AMENDMENTS TO THE DRAWINGS

REMARKS

Fig. 1

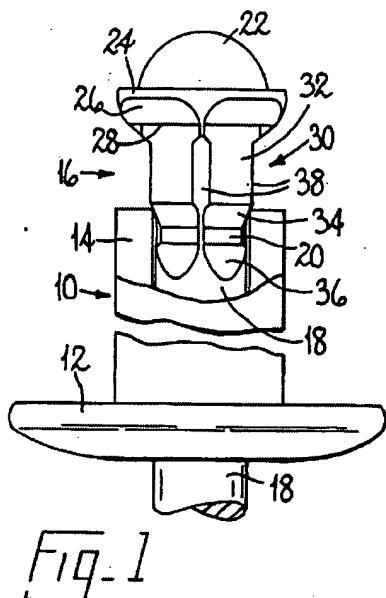
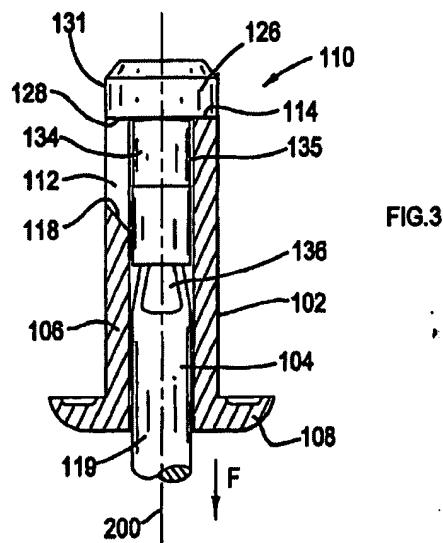
The Examiner's attention is directed to independent Claim 1. Claim 1 has been amended to include the limitation that the head portion has a shoulder portion, which is substantially perpendicular to the mandrel. The Office cites the Potzas reference as teaching this limitation. Applicant respectfully traverses this characterization. Applicant

would like to direct the Examiner's attention to Figure 1 of the Potzas reference, which shows the head 22 is coupled to the stem 18 using an angled surface 26.

This is opposed to Applicant's shoulder, which is perpendicular to the mandrel of the stem (114). The Examiner's attention is further directed to amended Claim 9, which contains the limitation that the mandrel stem has a reduced diameter section adjacent to the head having a circular cross-section. Applicant notes that none of the references teach this limitation.
